**SERVICE BULLETIN**

ENGINE - FUEL AND CONTROL - ENGINE DEDICATED ALTERNATOR (EDA) STATOR UNIT -
INTRODUCTION OF PERIODIC INSPECTION FOR CARBON DEPOSITS - CATEGORY CODE 3 -
MOD.ENG-73-0028

1664-73-004

ENGINE DEDICATED ALTERNATOR - STATOR UNIT
INTRODUCTION OF PERIODIC INSPECTION
FOR CARBON DEPOSITS

Inspection and Cleaning of the Stator Unit
Figure 1

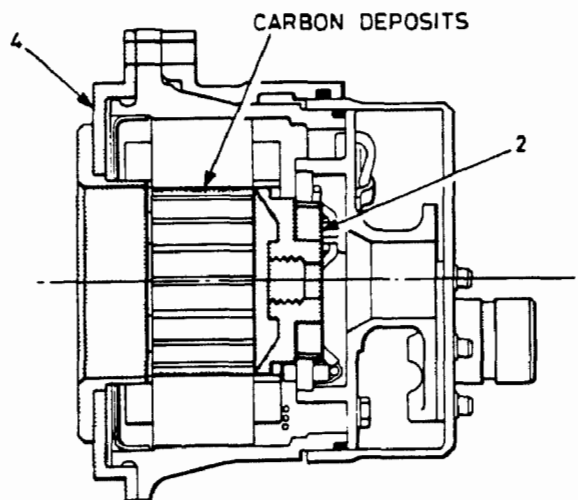
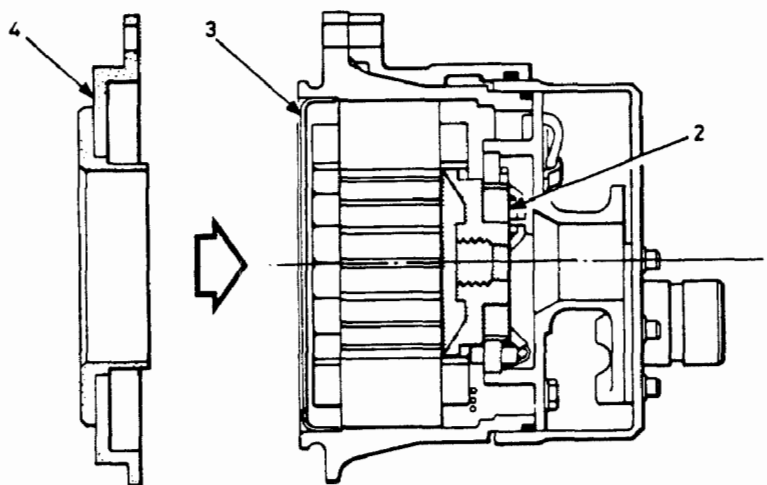
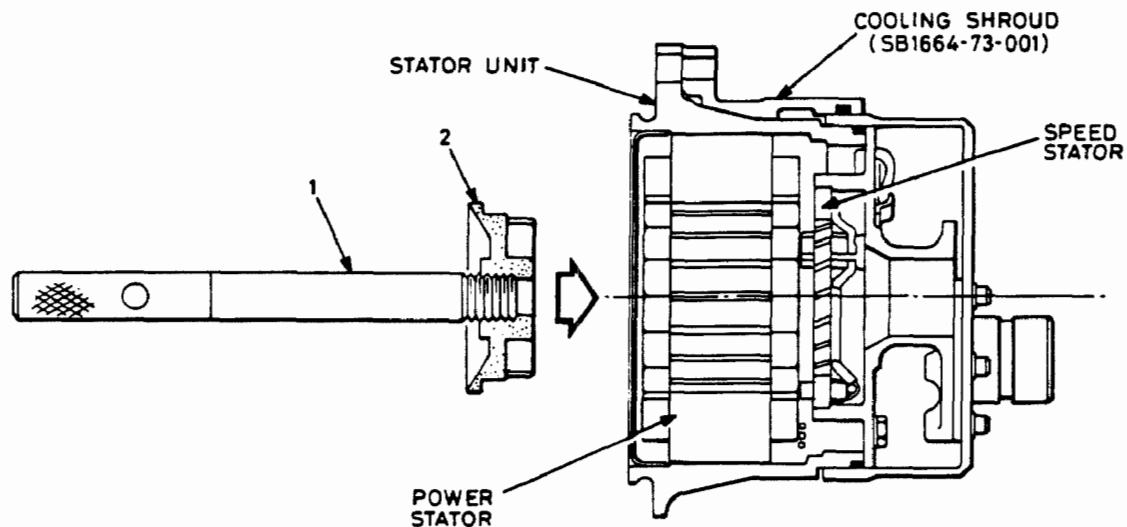
B. Inspect the Stator Bore (Figure 1).

- (1) Examine the power stator bore of the unit for evidence of carbon deposits on the surface of the stator bore where shown.
- (2) If any carbon deposit is evident in the power stator bore, clean the power stator bore in accordance with sub para 2.C.

C. Clean the Stator Bore (Figure 1).

- (2) Screw the handle (1) into the speed stator guard (2) and insert the guard through the power stator bore to engage the speed stator, at the outboard end of the Stator.

- (4) Install the power winding guard (4) to the Stator (over the winding guard (3)). Check the fit of the power winding guard (4), if the guard is loose, secure it to the Stator flange using slave 1/4 in. (0.250 in.) UNF bolts and nuts.

- (6) Fit the flexible honing tool (part of ANC 3089), to an air or electrically driven, rotary power tool which has a set speed of 190/210 rpm.
- (7) Hold the Stator firmly, start the power tool and insert the honing tool as far as possible into the bore (of the power stator) and then immediately remove it; do not let the honing tool stay in the stator bore.

- (8) Inspect the bore (of the power stator), which should show clean metal over the full length. If any carbon deposit remains in the bore, repeat sub. para. 2C (7).
